**COUNTY OF WESTCHESTER
NEW YORK**

ADDENDUM NO. 3

CONTRACT NO. 20-502

**LOW RISE BUILDING RENOVATIONS AND
HVAC IMPROVEMENTS - PHASE II
110 DR. MARTIN LUTHER KING, JR. BOULEVARD
WHITE PLAINS, NEW YORK**

| REFLECTED CEILING PLAN - GARAGE LEVEL B2 - CENTRAL WING | | DPW FILE NO. | 52-11-A-1836-0 |

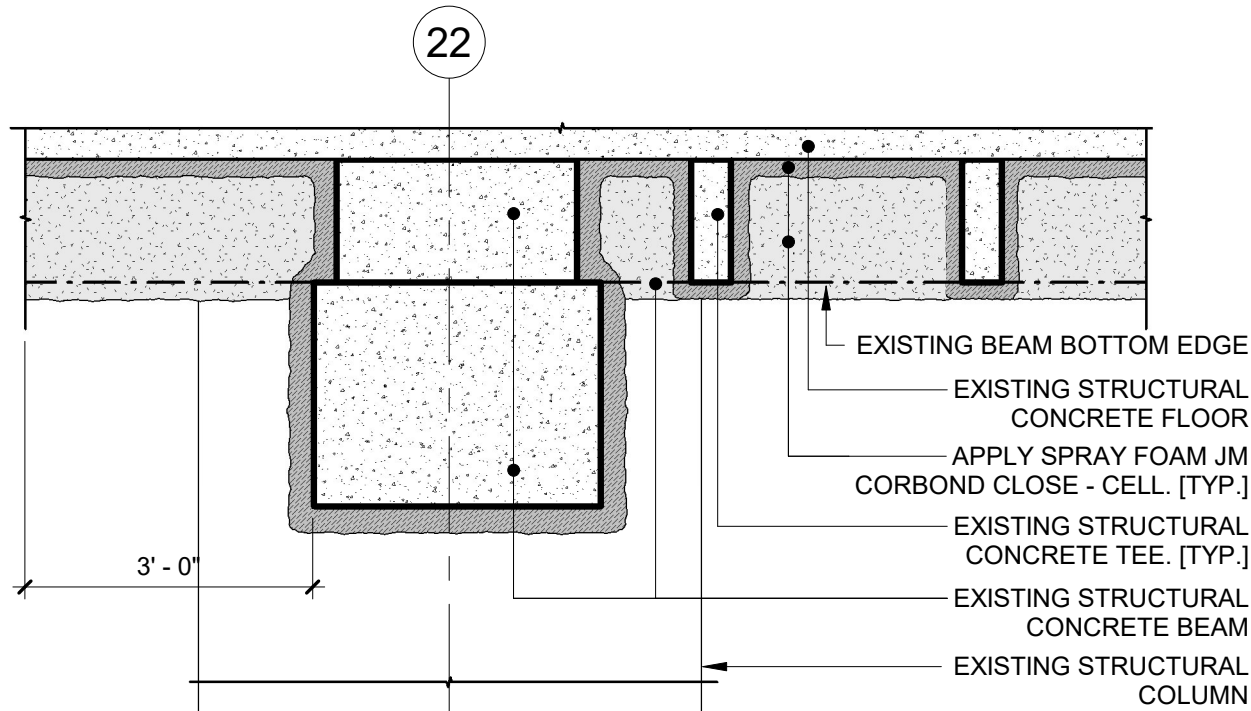
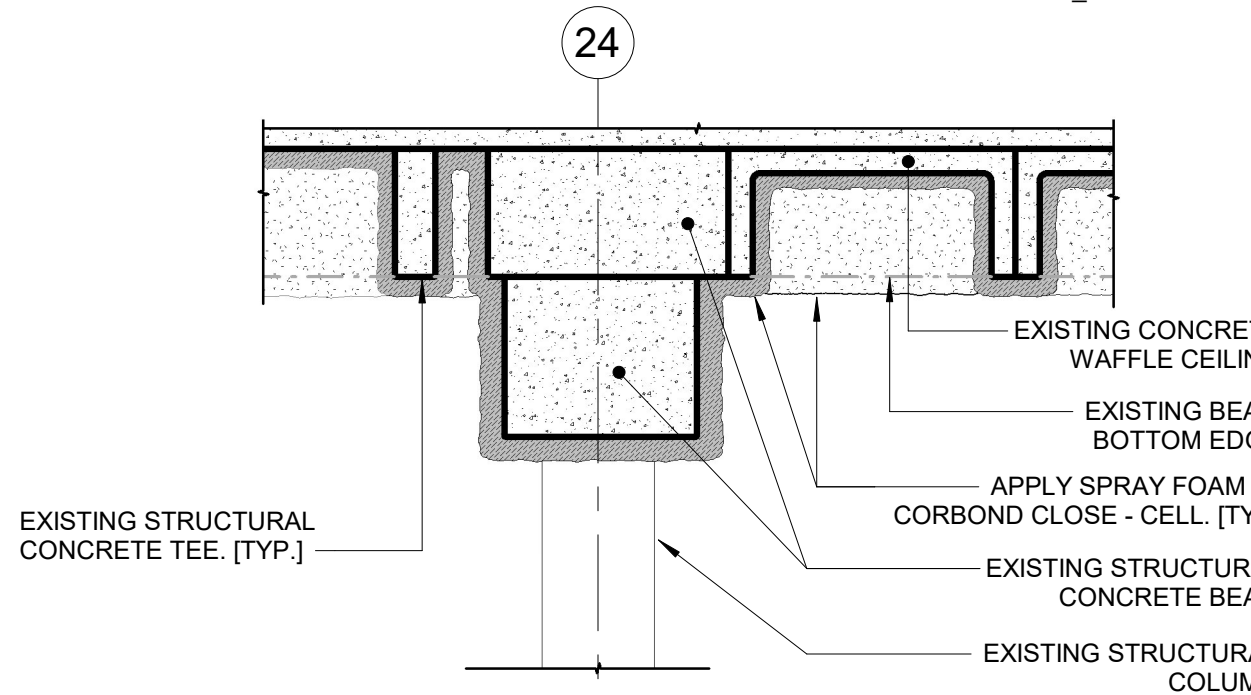
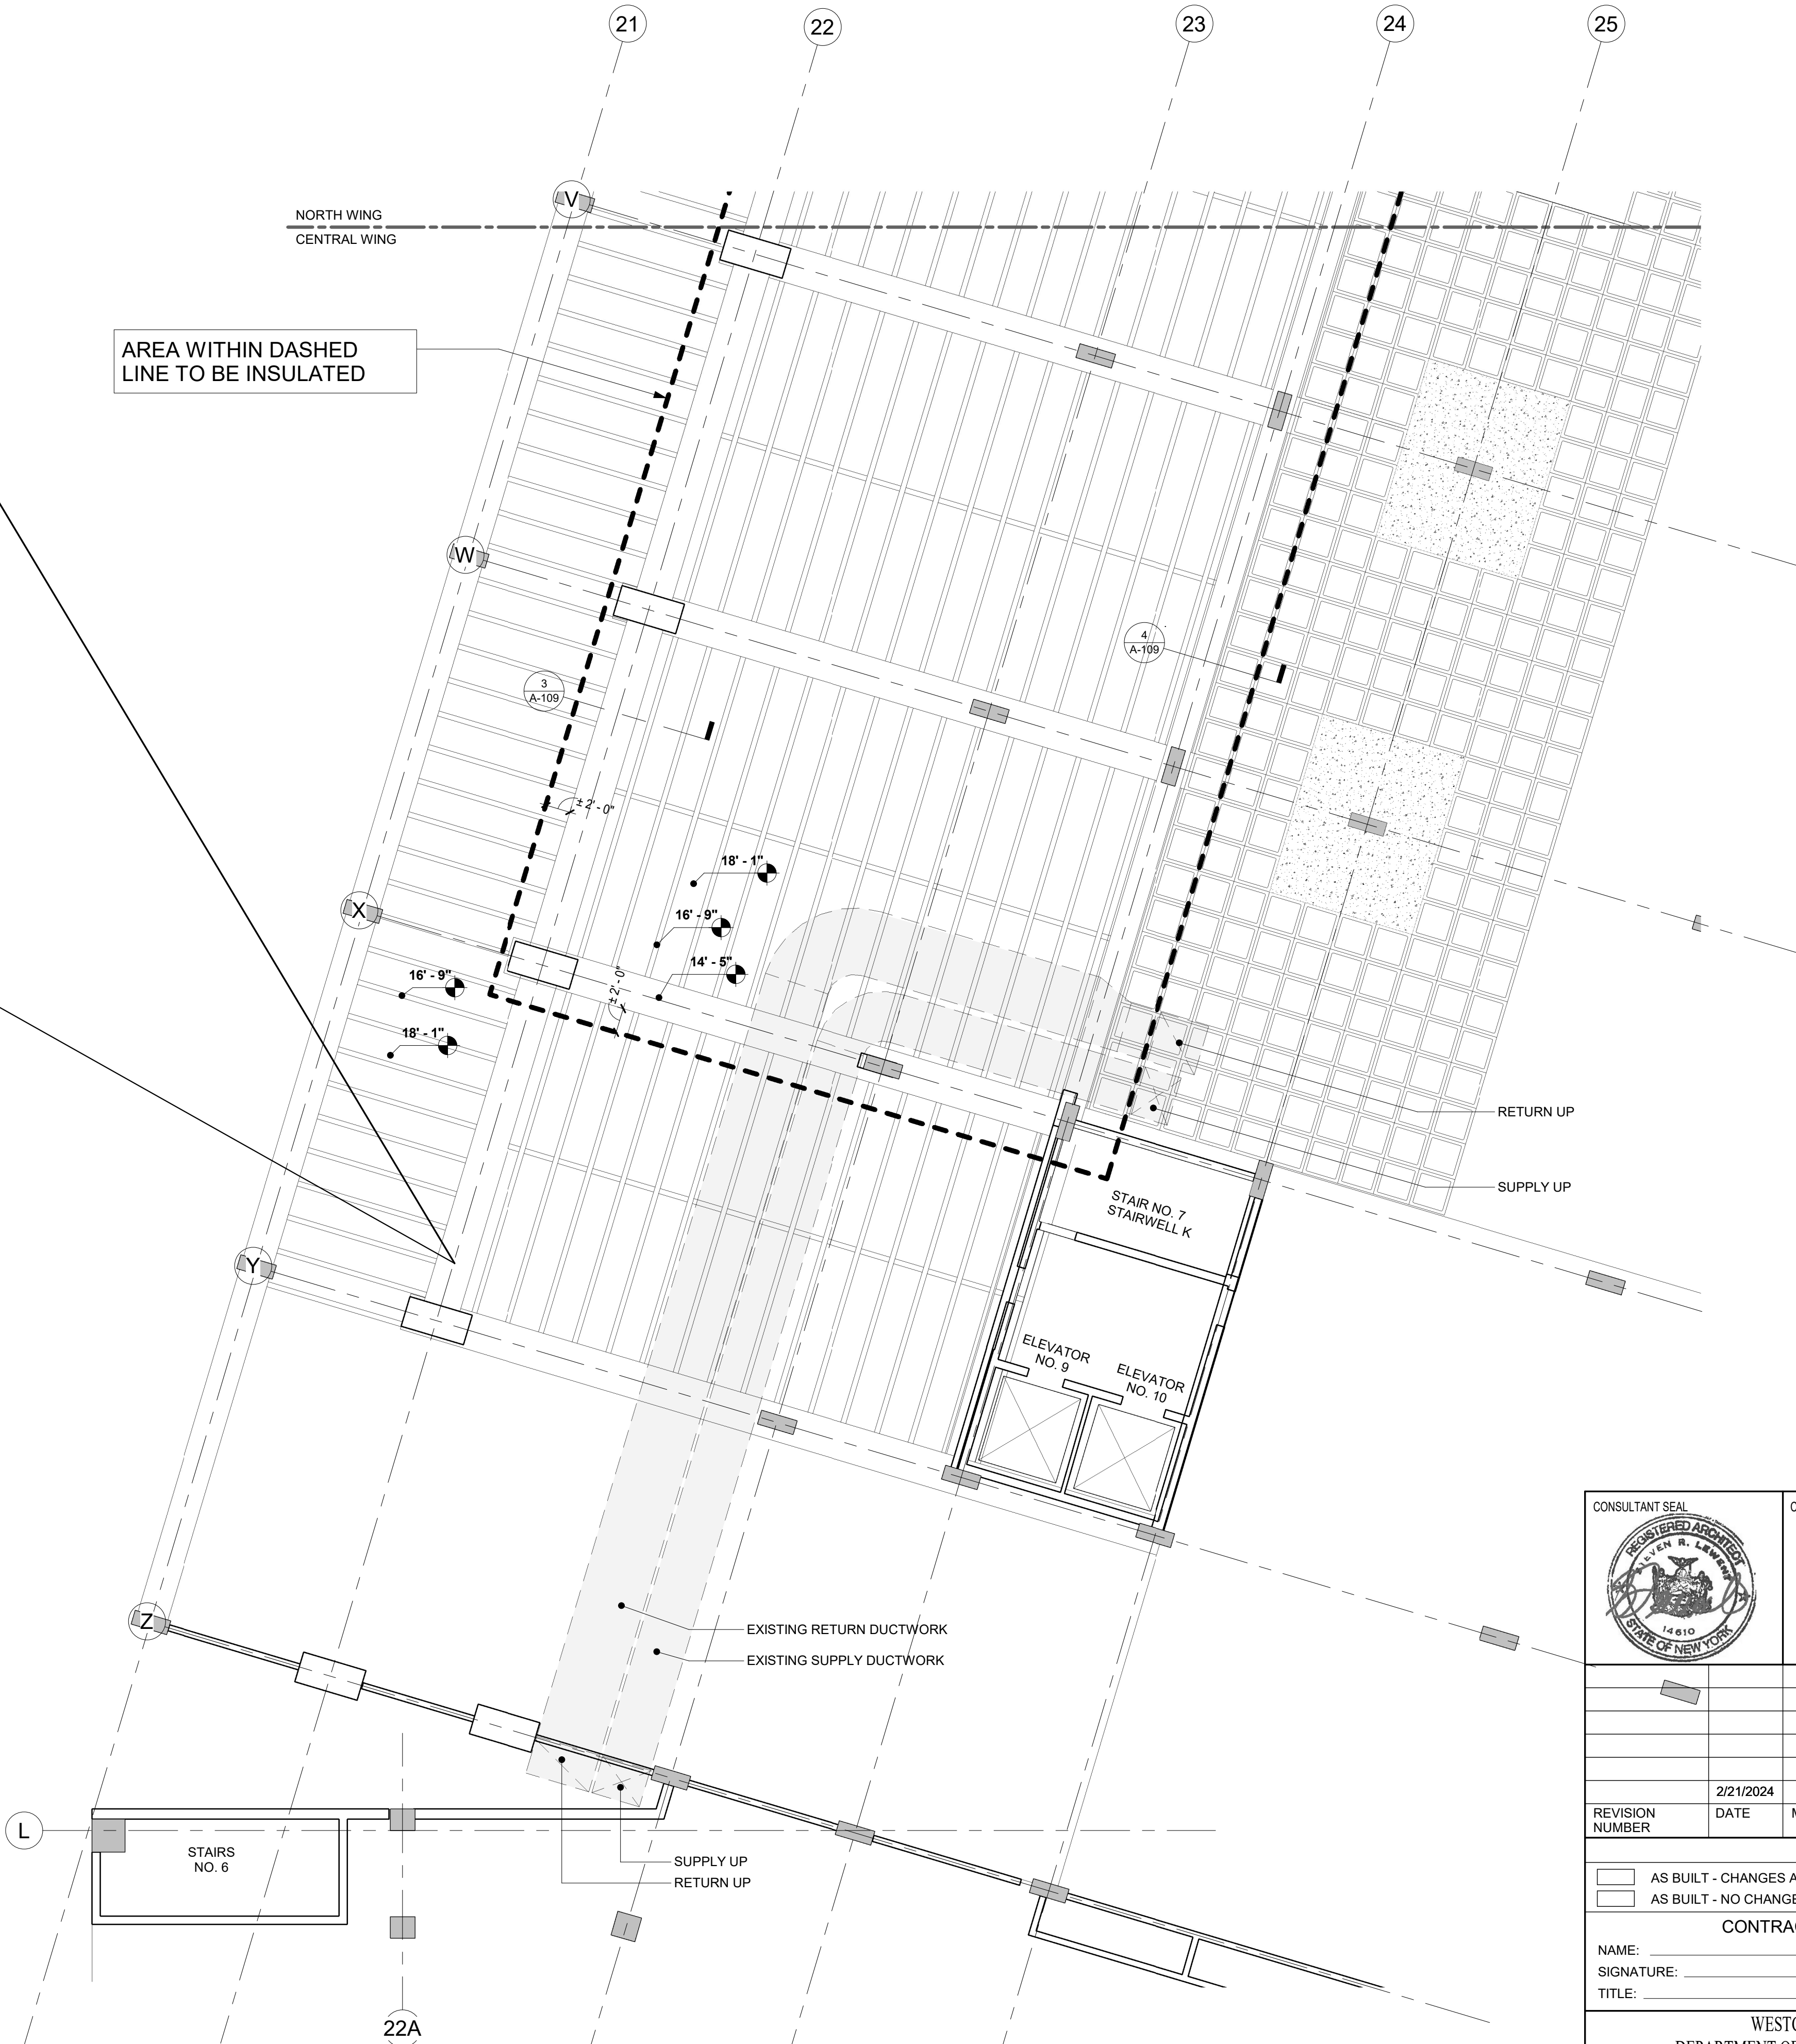
| Q25 | DWG A109 indicates Open Cell Spray Foam. Spec section 072100 indicates Closed Cell Type Insulation. Please confirmed material is closed cell at the Garage Level B2. | The note on A-109 has been revised. GC to provide closed cell spray foam. |
